City of Detroit - Planning & Development Department
2 Woodward Avenue, Suite 808
Detroit, Michigan 48226

HISTORIC DISTRICT COMMISSION ADDITIONAL INFORMATION REQUEST

Application Number: HDC2025-00635

NAME: Brett Mahaffey		COMPANY NAME: Renewal by Andersen	
ADDRESS: 37720 AMRHEIN RD	CITY: Livonia	STATE: MI	ZIP: 48150
PROJECT ADDRESS: 12512 Broadstreet Ave			
HISTORIC DISTRICT: Russell Woods-Sullivan

**Full Divided Light (FDL) Grille**

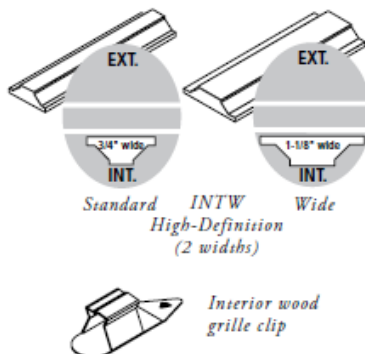
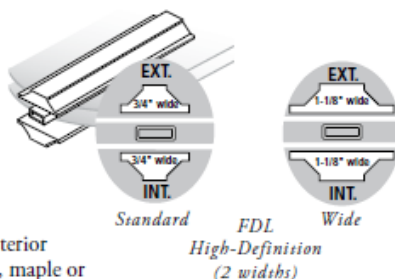
Does this window line offer simulated divided light windows?

The windows can be FDL (what's approved) the contract is GBG and I know that will not be approved, also the contract has incorrect grille patterns on it, and if approved, the contract will be fixed with matching grille pattern configuration (2 over 3, etc) and FDL (full divided light (simulated))
